PROPOSED TECHNICAL SPECIFICATION CHANGES

ELECTRICAL POWER SYSTEMS

DRAWING 3

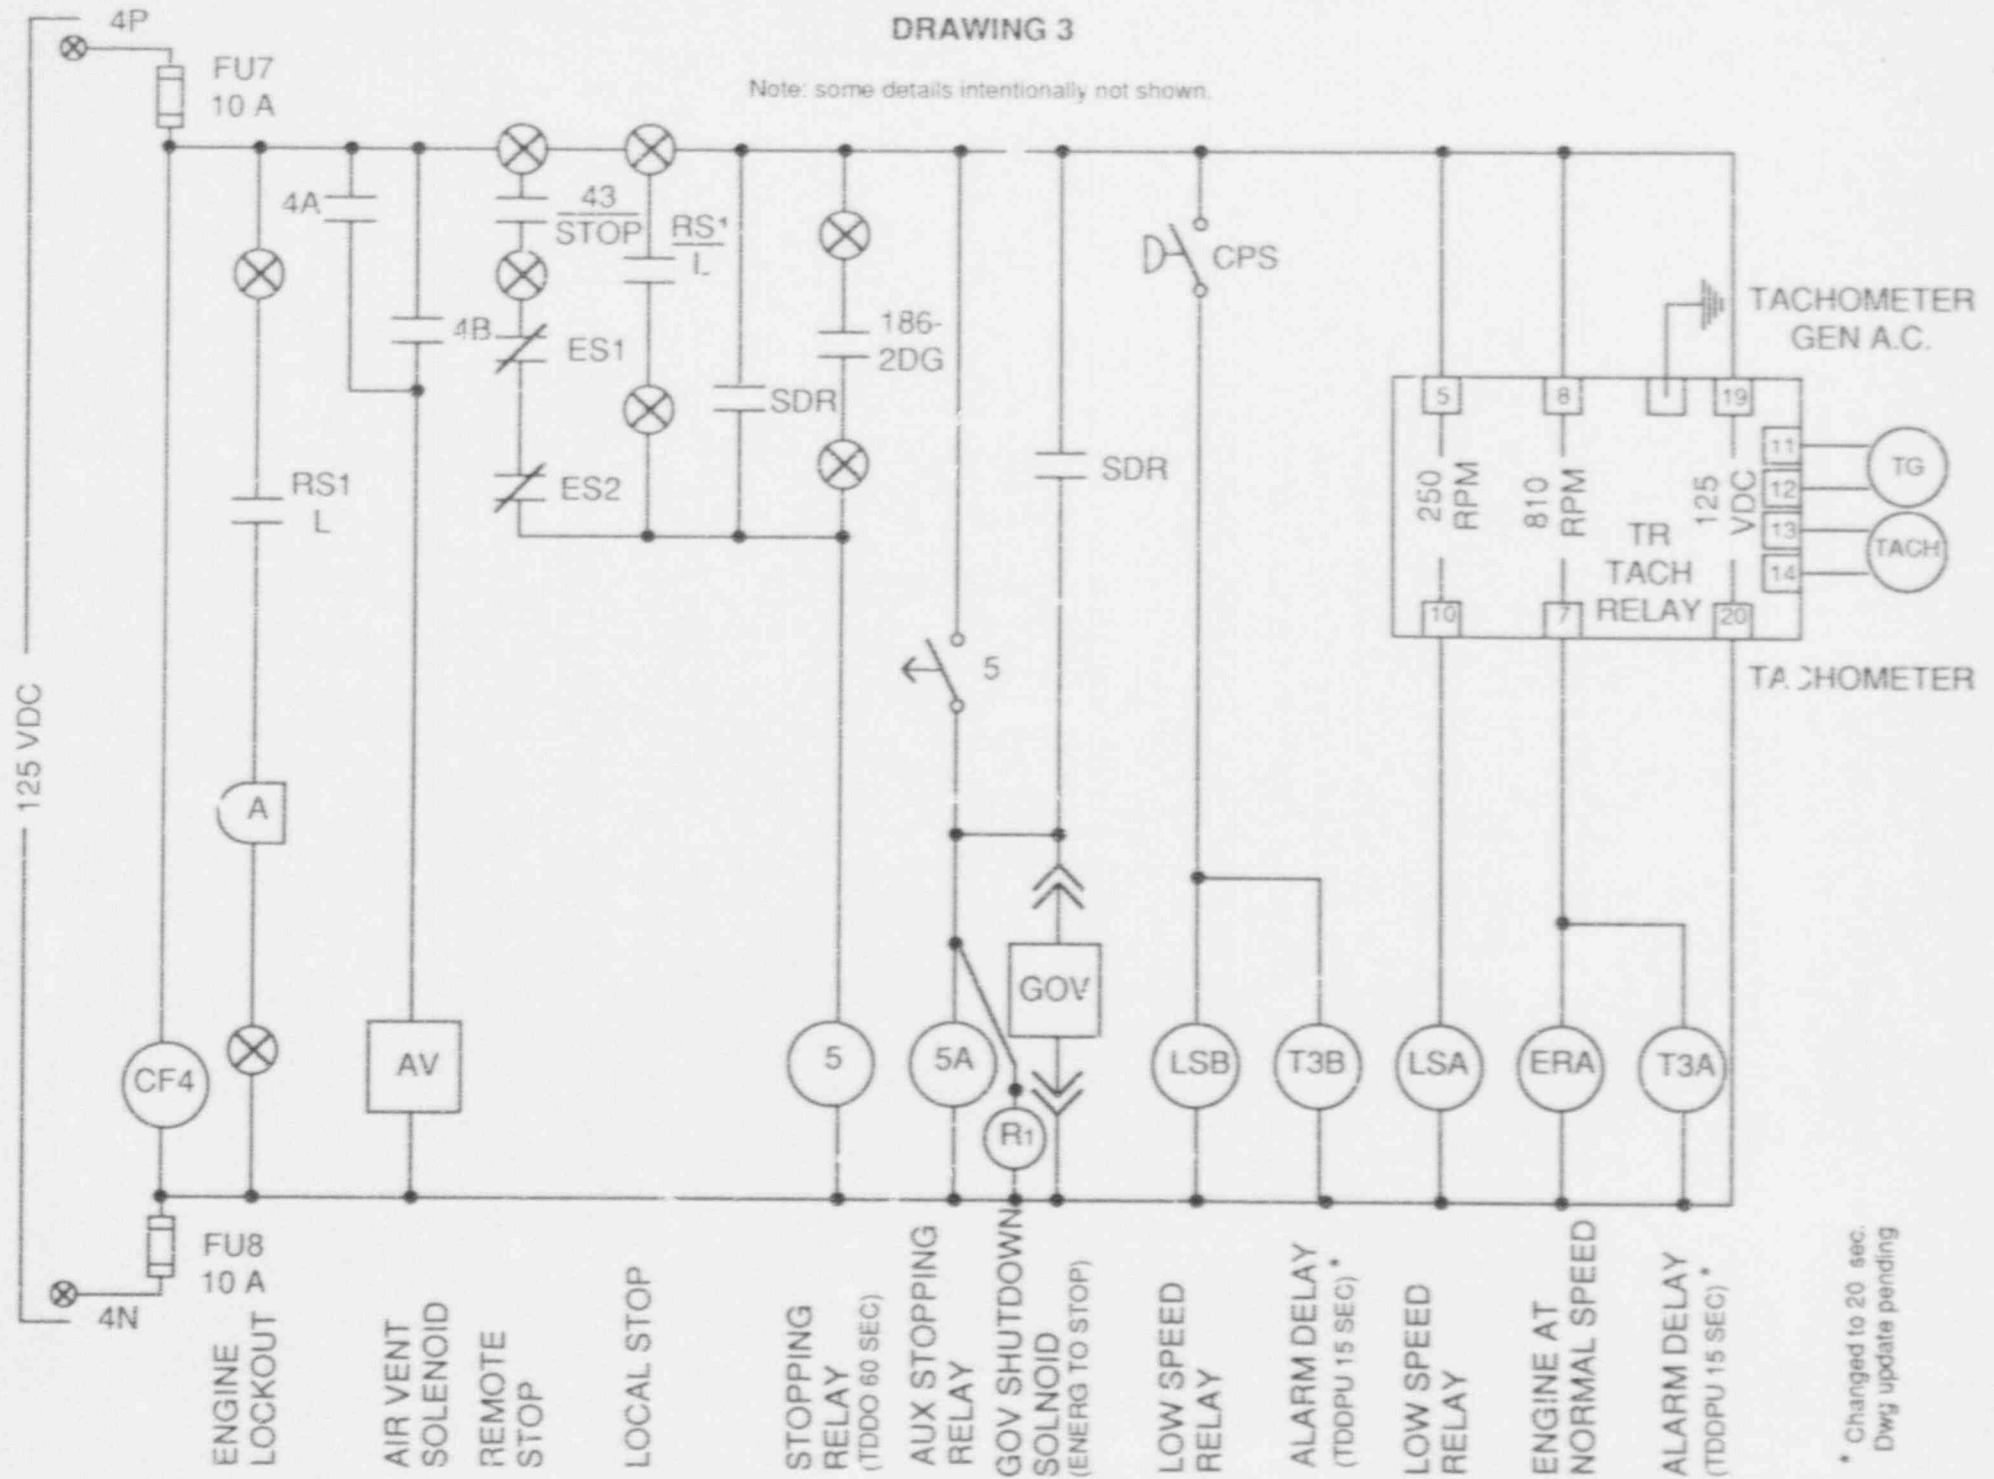
* Changed to 20 sec.
Dwy update pending

DRAWING 4A BEFORE DCP

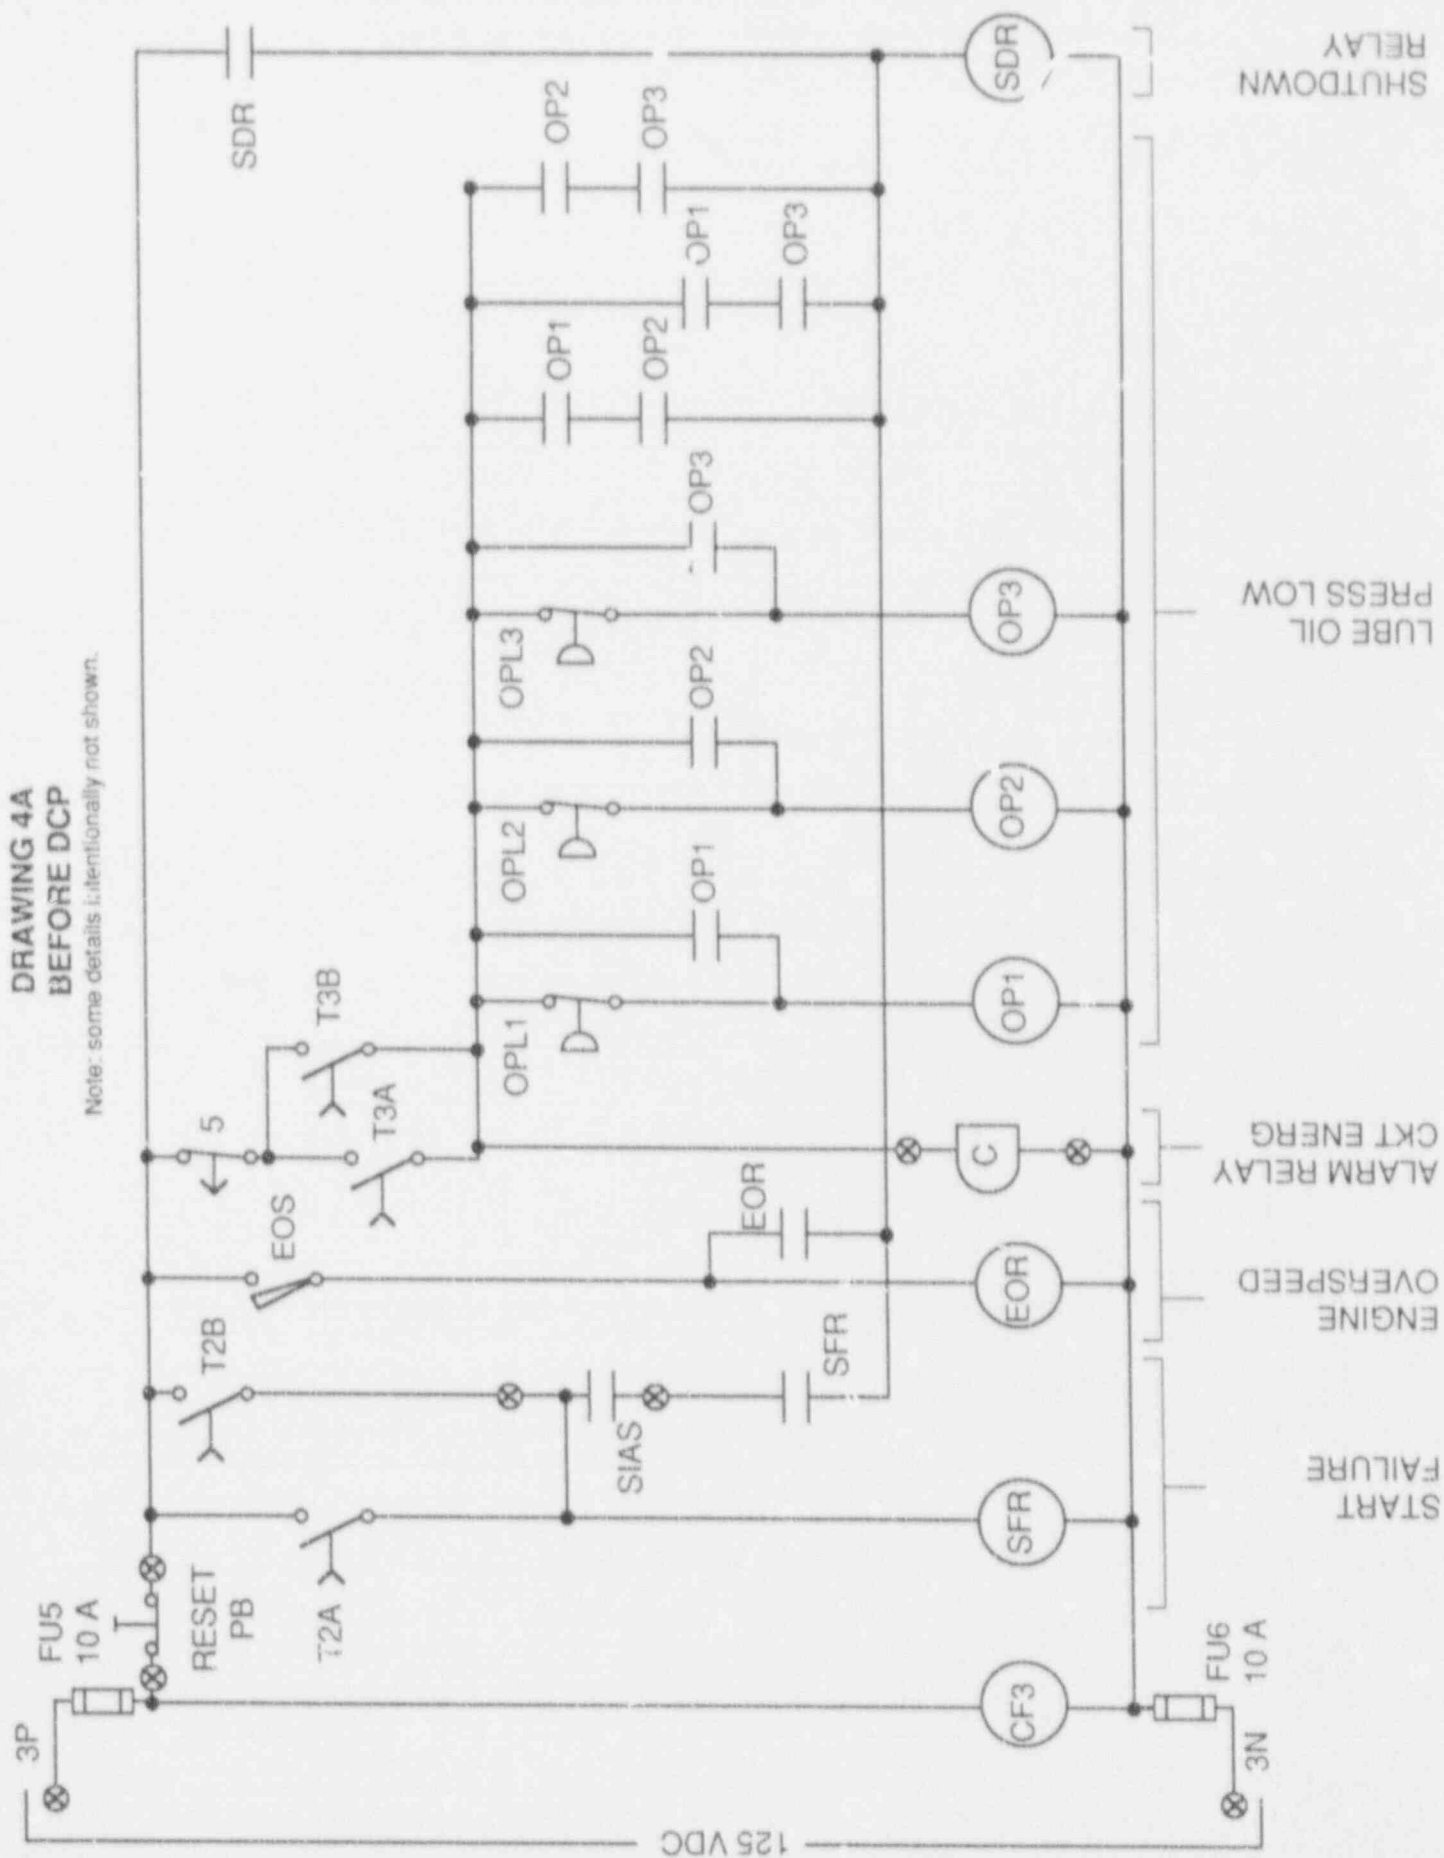
DRAWING 4B AFTER DCP
